PLANNING BOARD WORKING MEETING

a. Project: Site Plan, Village Solar Phase VII

VILLAGE CIRCLE-VILLAGE SOLARS PDA - PHASE VII 1067 WARREN ROAD LANSING (T), NEW YORK

Village Solars Phase 7 – Response to August 18, 2022 TG Miller Comments

SECTION A - A
Vertical Scale = 10X Horizontal

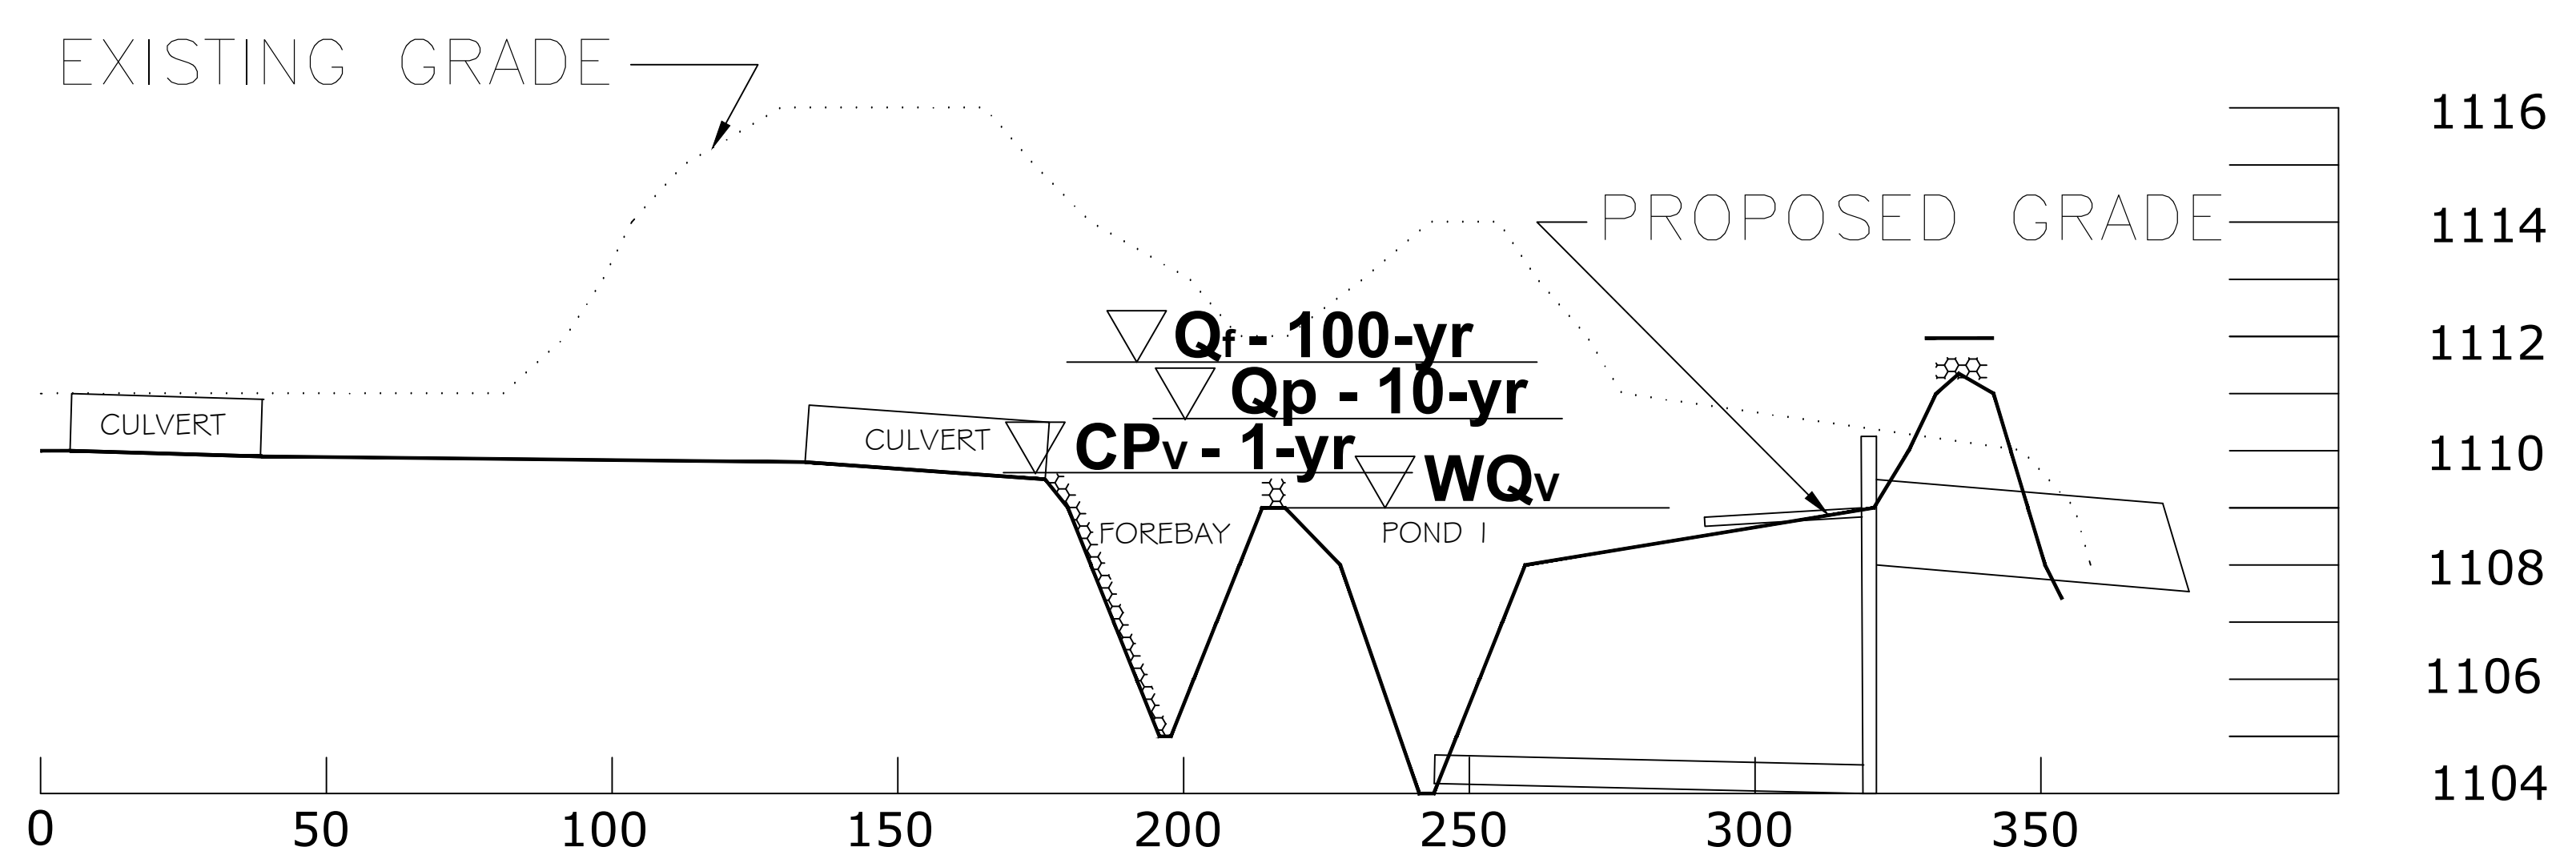
12. Comment: There is a pond shown on the subcatchment map but there is no further information on this structure.

Response: *The missing pond design sheet has now been included to the plan set, and the site plan has been updated to show Pond 1, which is required for the attenuation of OSC-3.*

DATE:	Sept 6, 2022
SCALE:	N.T.S.
DRAWN:	SDG
JOB:	
SHEET:	ST-7

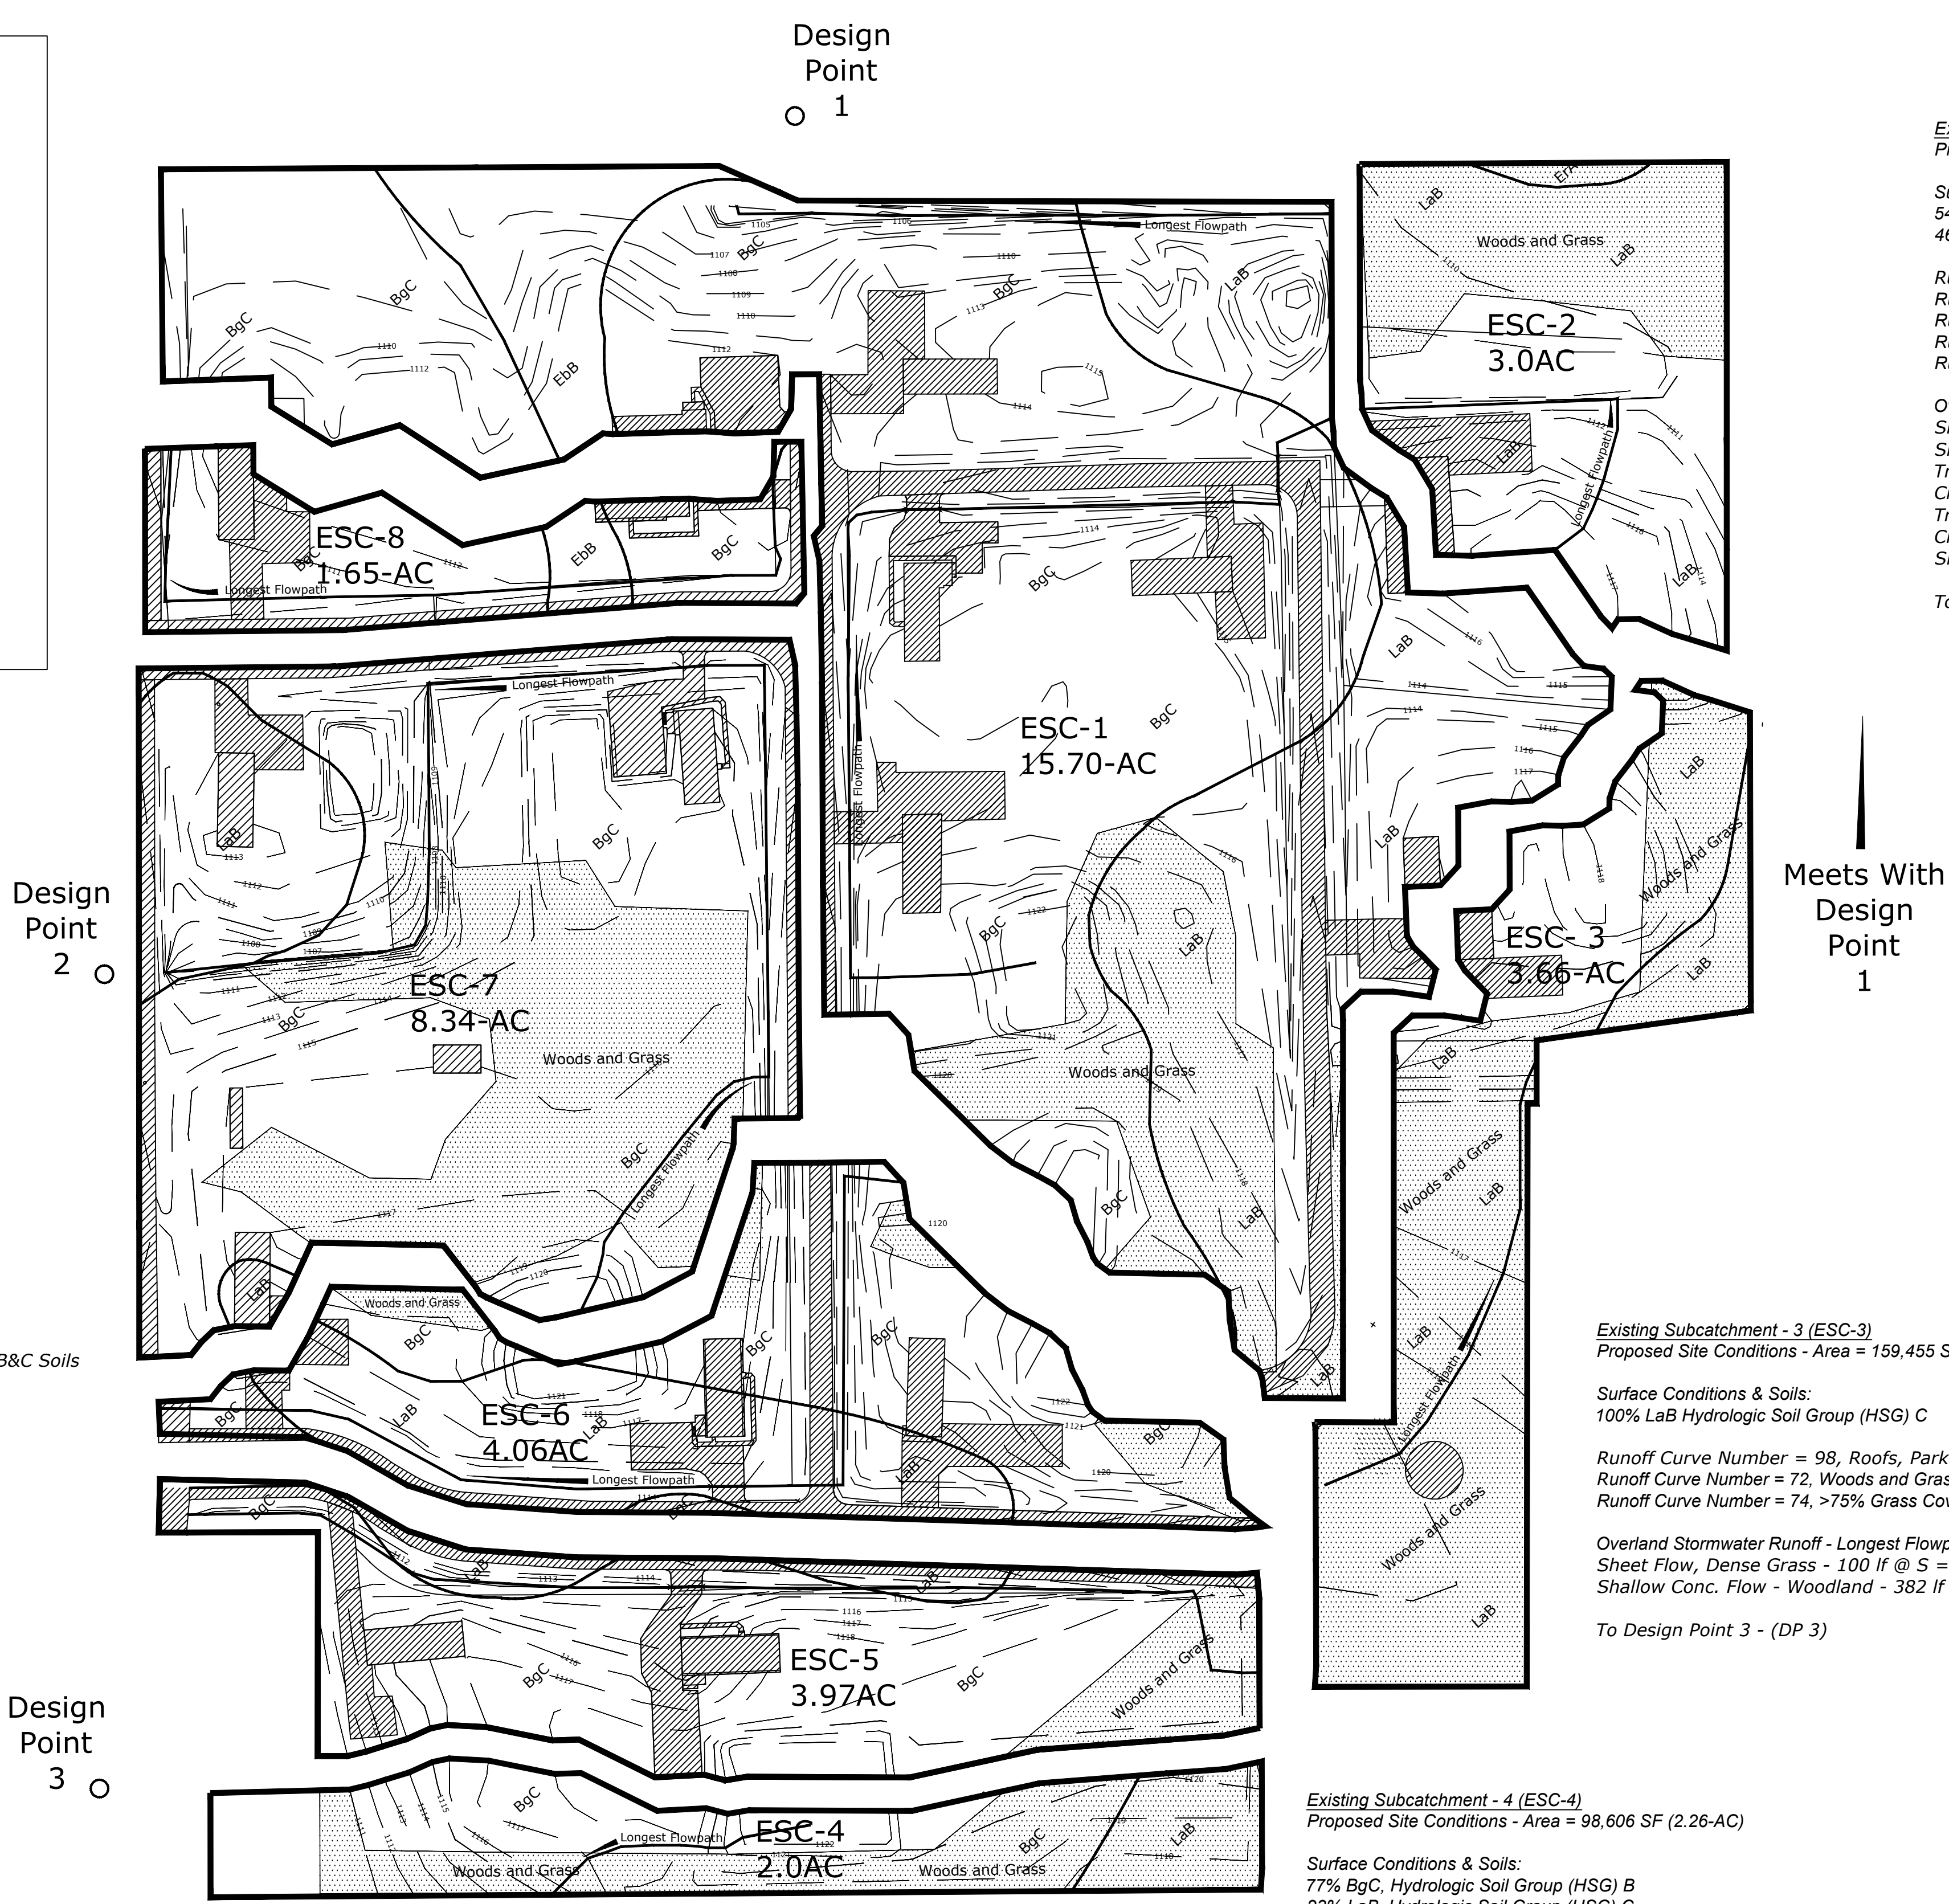
19. Comment: Watershed map ST-7 shows an existing diversion swale along the north side of ESC-1. It is recommended that this be evaluated to determine its capacity.

Response: The swale will be walked to identify whether it can handle the needs of flowrates for Design Point 1. Still, Existing Subcatchment modeling for the 100 yr rain event shows runoff values to be in the neighborhood of 42 cfs, which is roughly the proposed output from the developed model. Things are not anticipated to change.

RECORD DRAWING

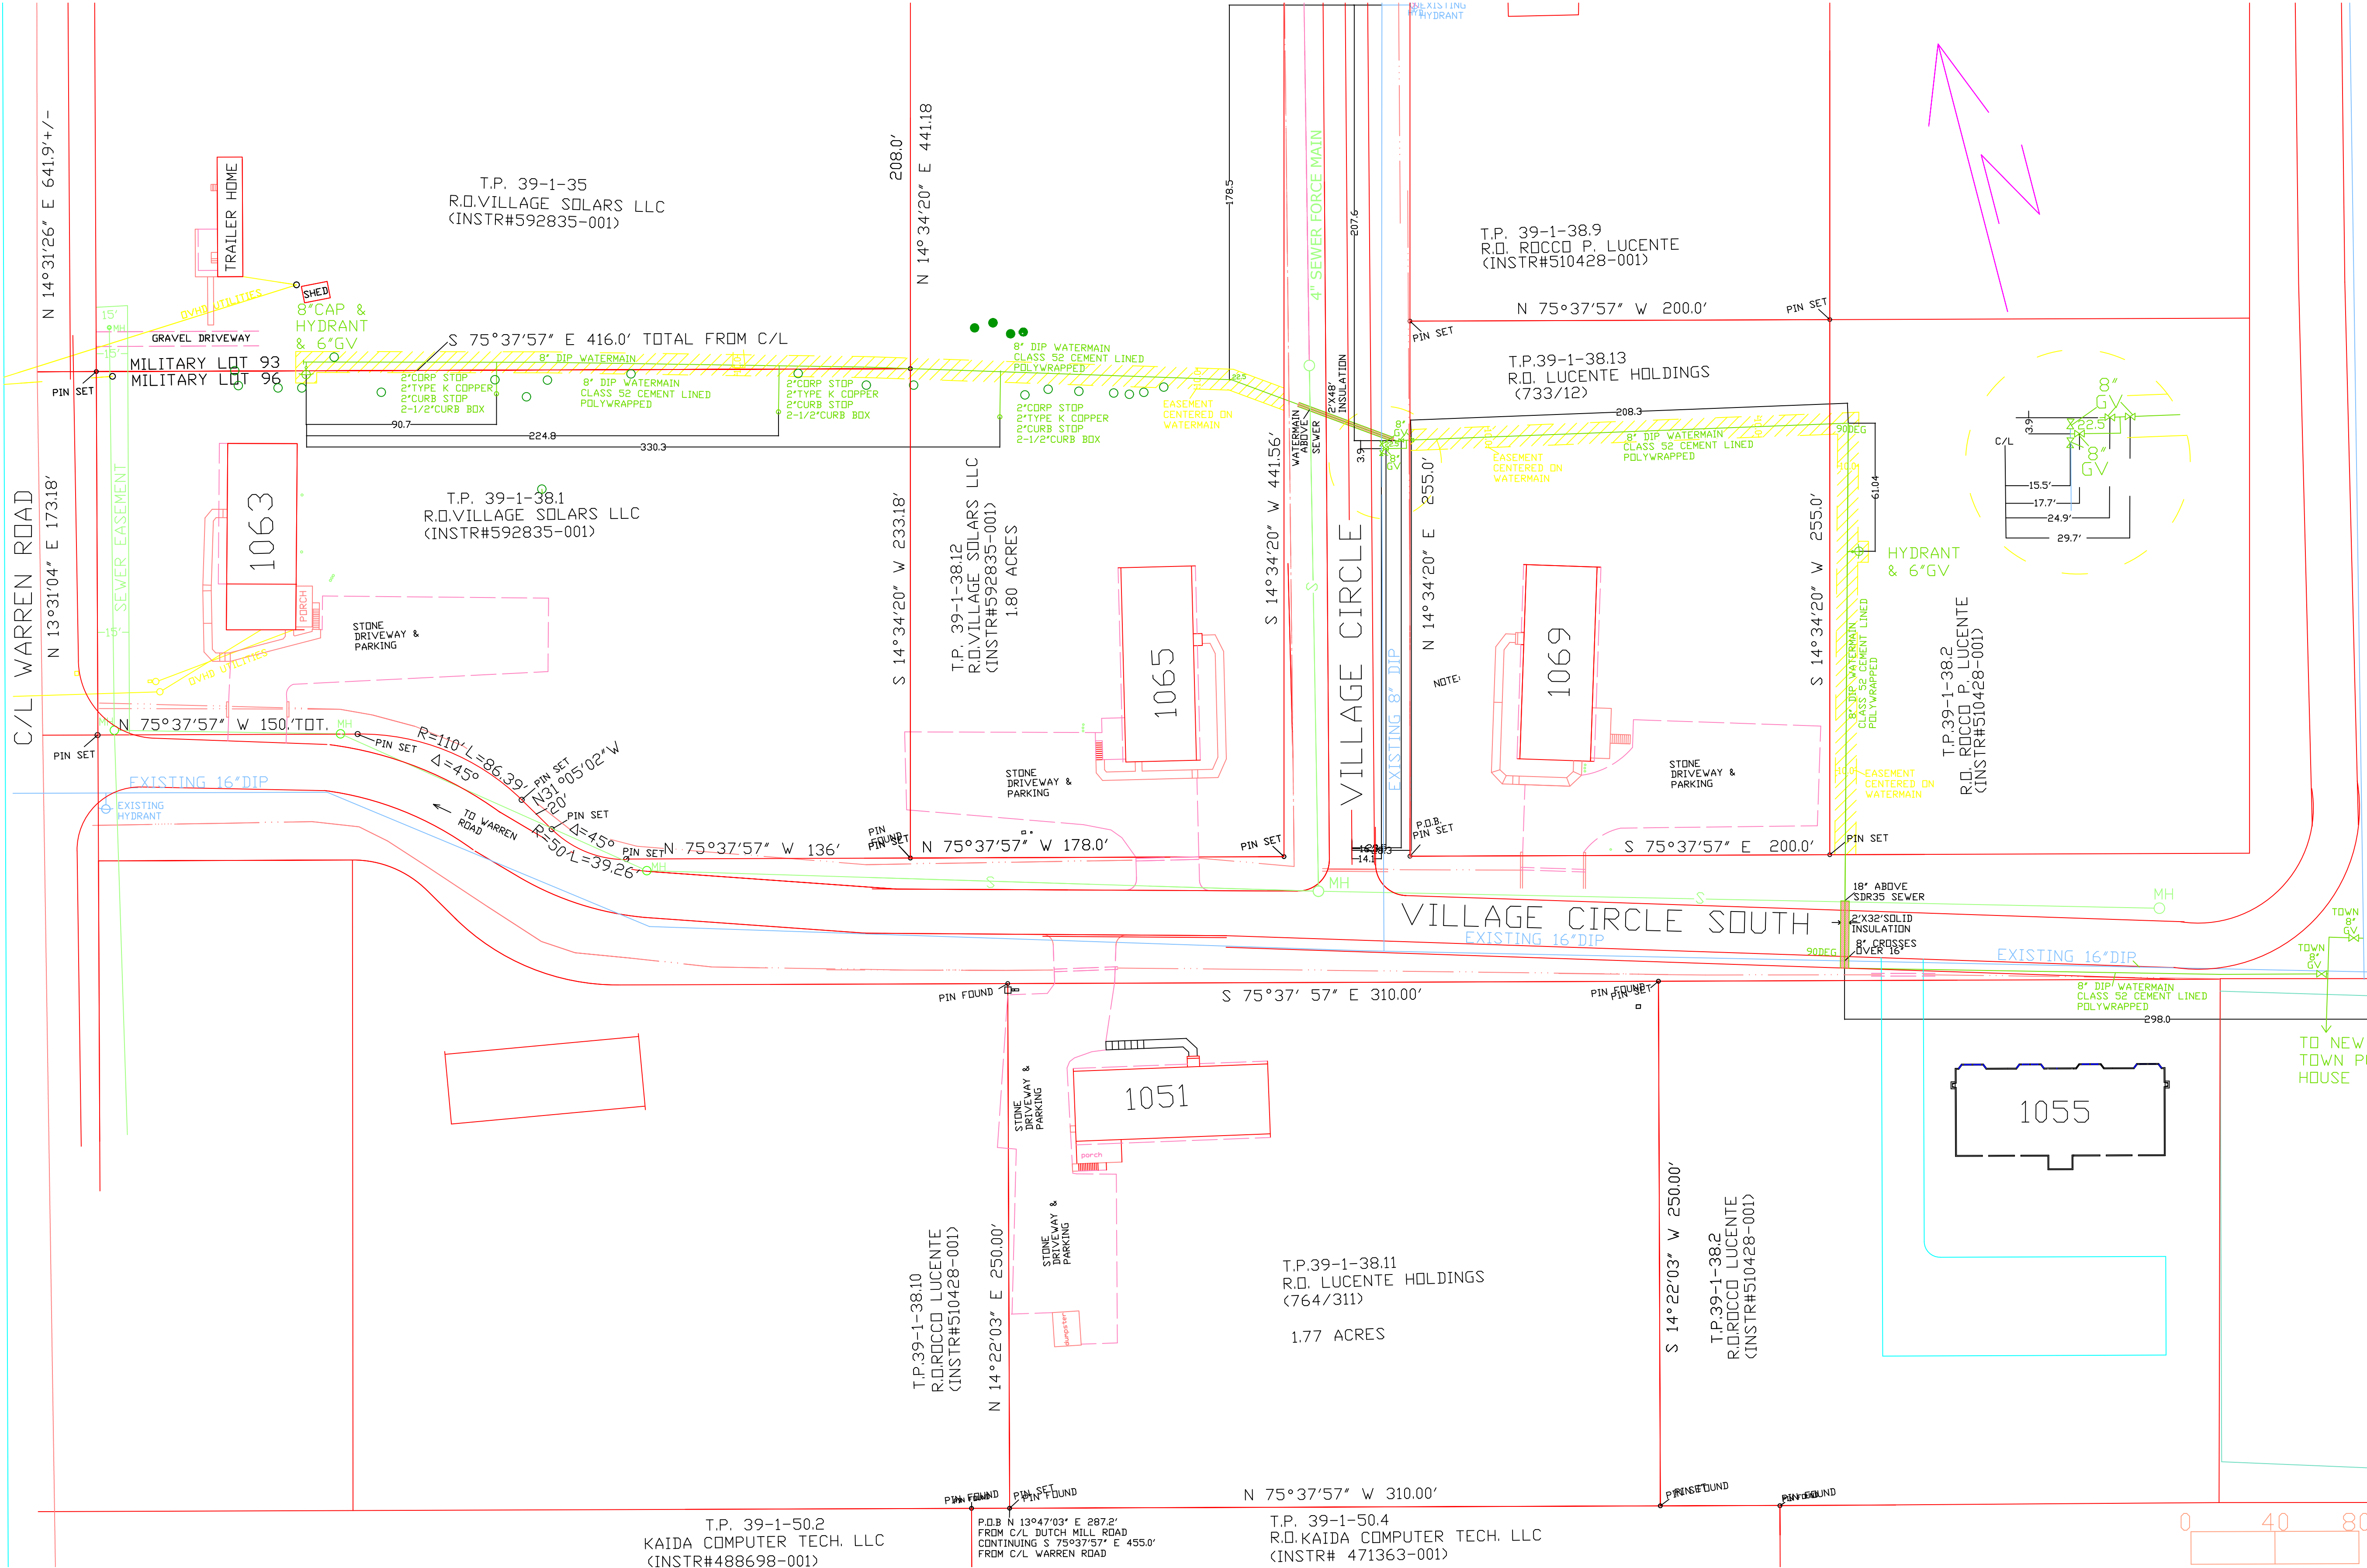
1. Comment: Show water service connections for Lots 37 and 70 being connected to Bone Plain Pressure Grid. Additional municipal main extension may be required if not previously installed.

Response: All of the proposed water services for this final Phase 7 will be from the Bone Plain Pressure grid. The water main has already been extended and the as-built drawing has been made as part of the plan package.
